**UNITED STATES DEPARTMENT OF COMMERCE
Patent and Trademark Office**

APPLICATION NO.	FILING DATE	FIRST NAMED INVENTOR	ATTORNEY DOCKET NO.
09/398,652	09/17/99	SAMARAS	W 042390.P5120

Office Action Summary	Application No.	Applicant(s)	
	09/398,652	SAMARAS ET AL.	
	Examiner	Art Unit	
	Rick K. Chang	3729

DETAILED ACTION

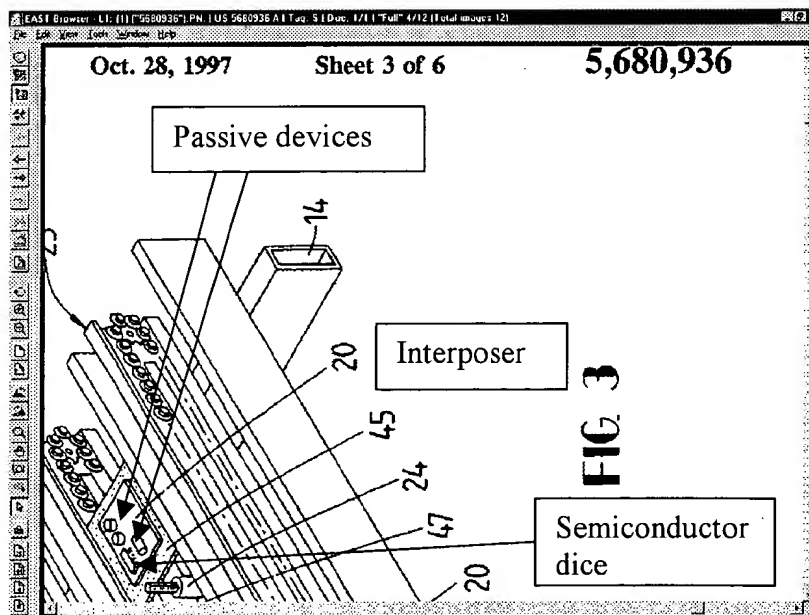
Beers discloses coupling at least one passive device (see annotated Fig. 3 below) thereby regulating voltage and current to the electronic dice.

Further, it would have been obvious to one of ordinary skill in the art at the time the invention was made to modify Seidel by coupling at least one passive device to the first surface of the interposer, as taught by Beers, for the purpose of regulating voltage and current to the electronic chip.
